# Request For Information RFI-087

Subject:BP3 Stage F2 DeletionDate: 09/17/2021Project:Steamboat - BV BP Promenade and GoldwalkJob: 2001502104Address:2305 Mount Werner CircleRequired: 09/22/2021

**Subject:** F2 double headed pedestrian lights at stage

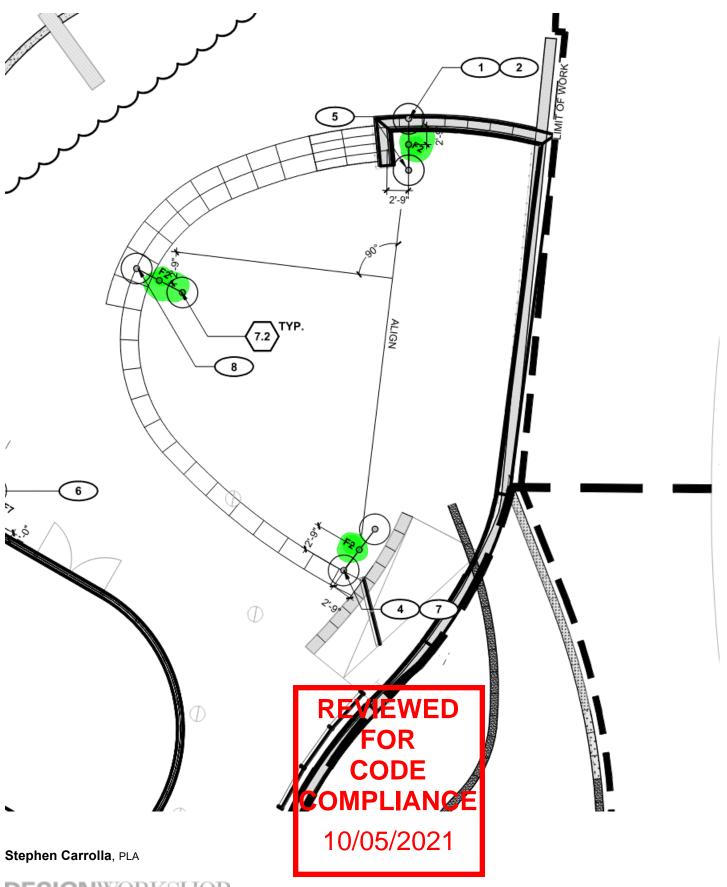
future stage canopy.

The (3) F2 double headed pedestrian lights shou that led at the level d plaza these will conflict with the

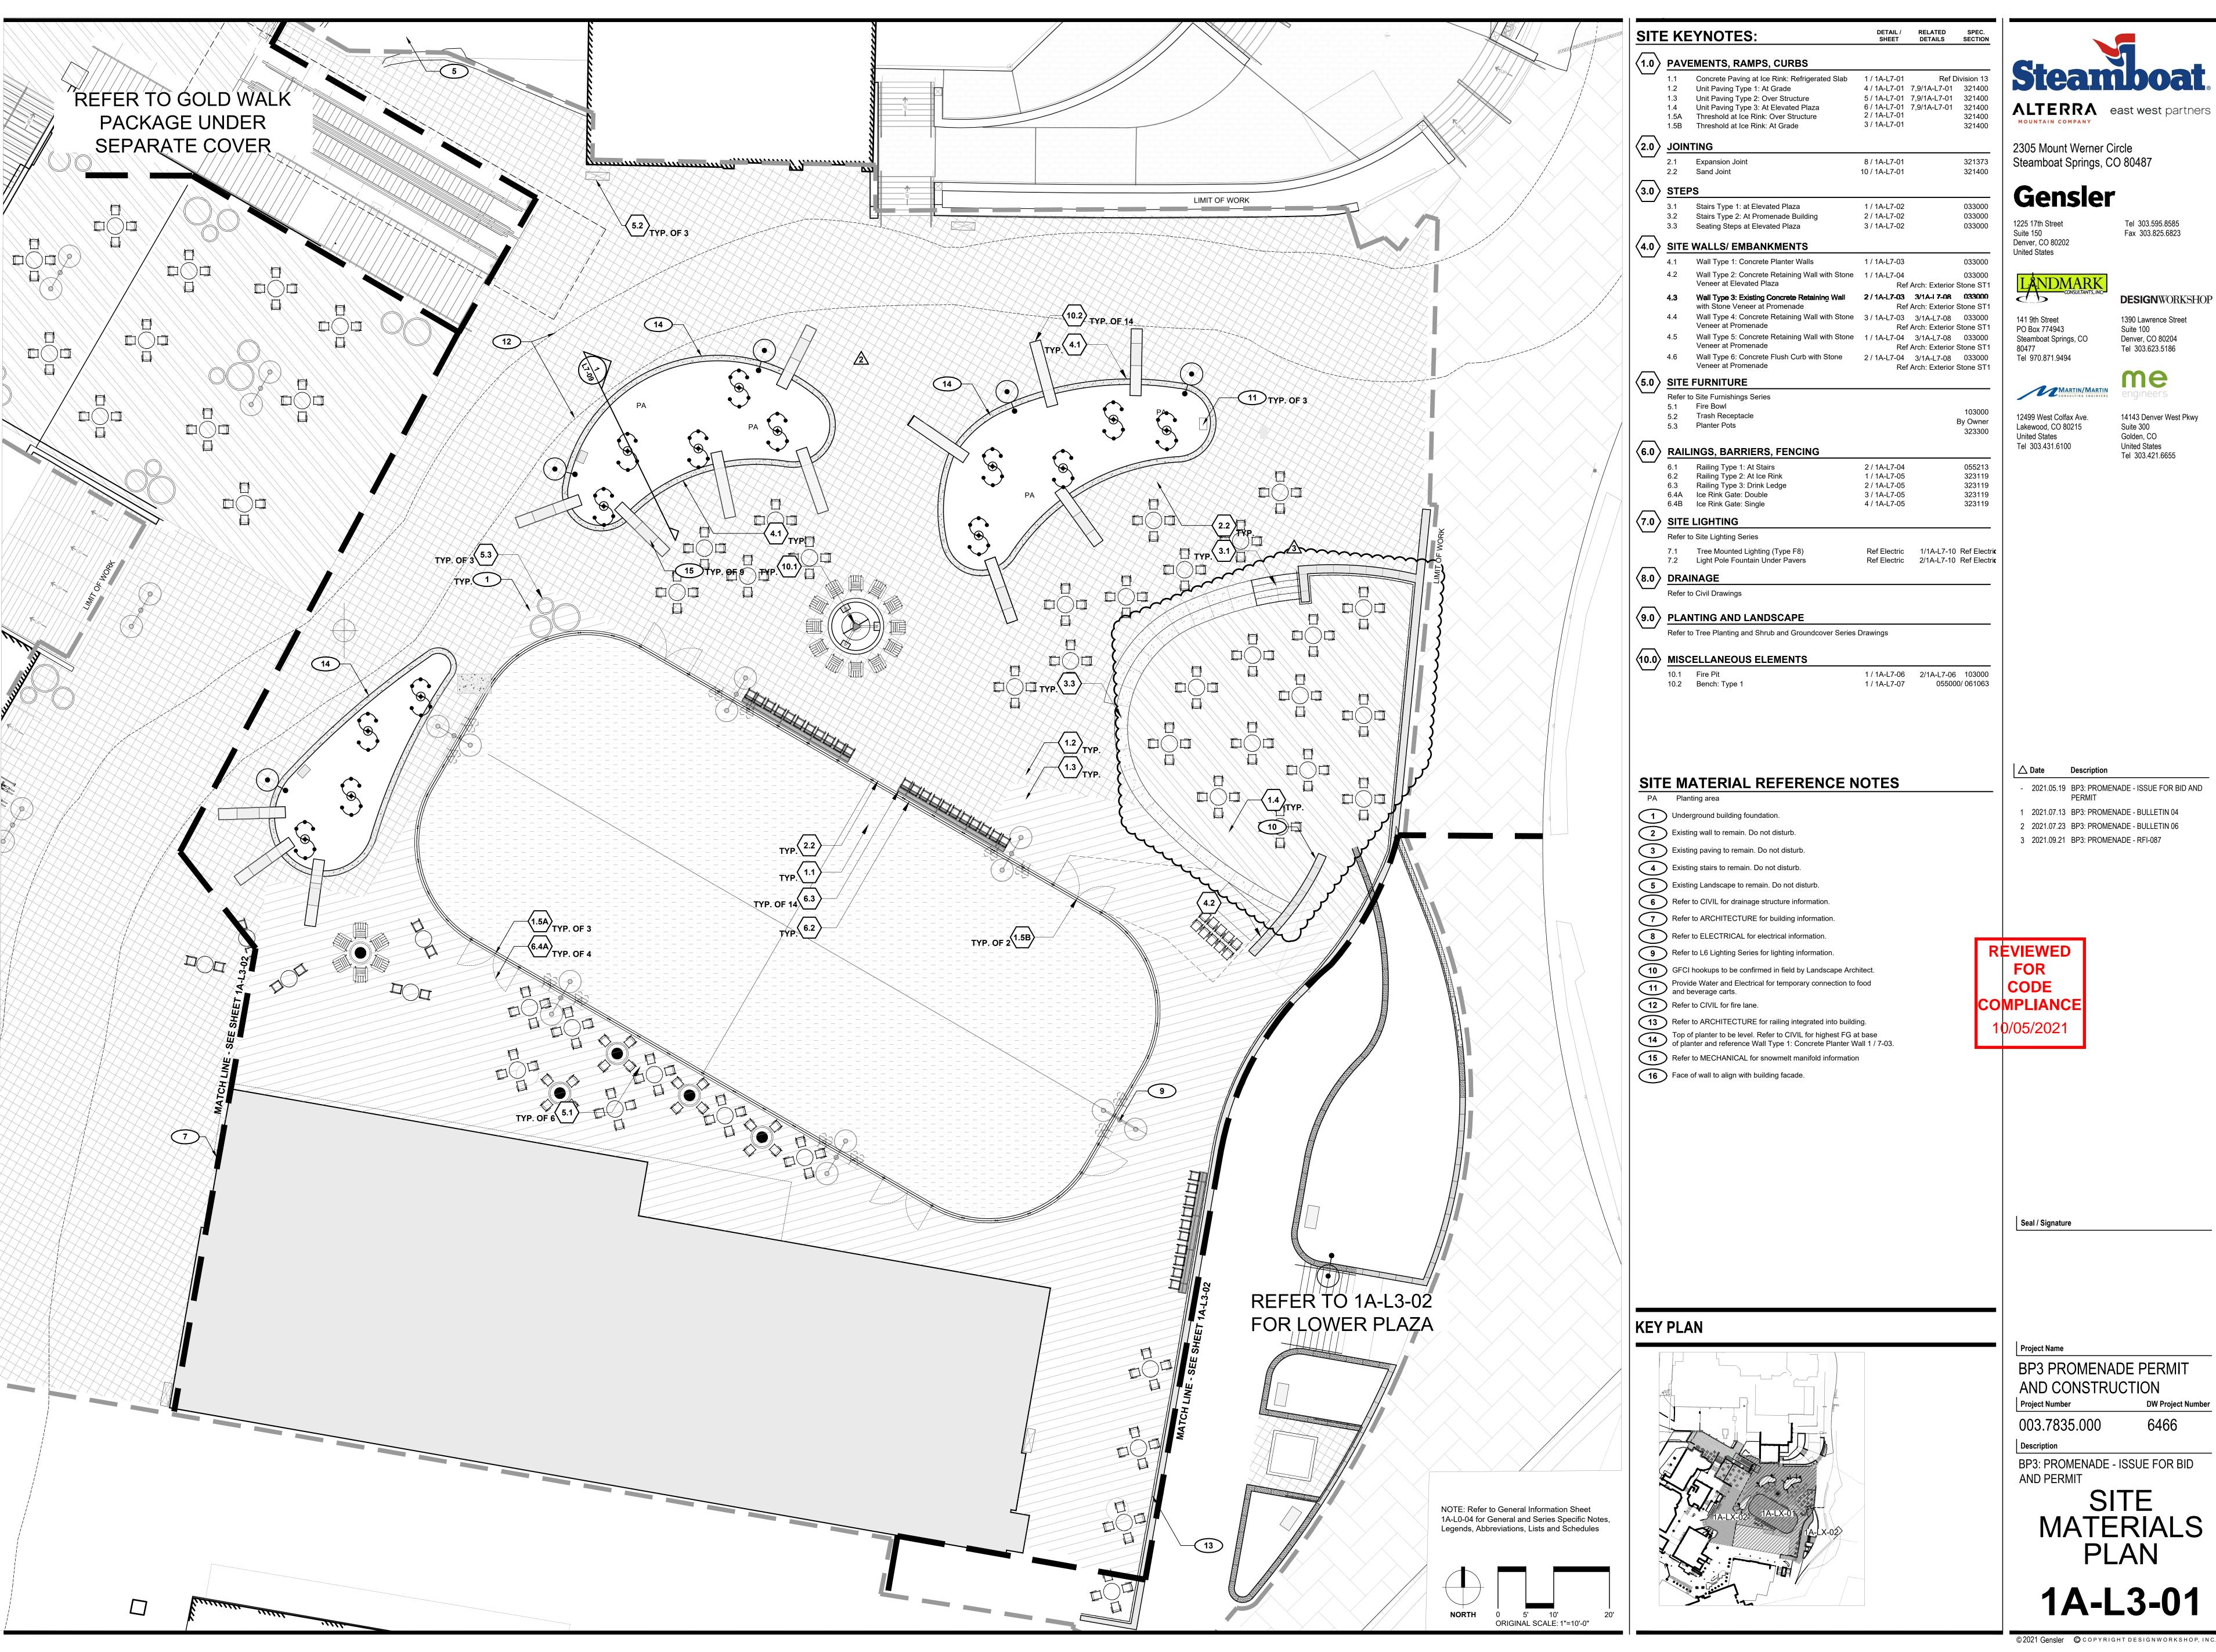
Ref attached correspondence- the (3) F2 double headed pedestrian lights at the Promenade stage shown on 1A-L6-01 should be deleted entirely from scope.

Please confirm deletion of the F2 lights as noted and provide revised construction documents capturing change.

The (3) F2 double headed pedestrian lights at the Promenade stage should be omitted from the project scope.
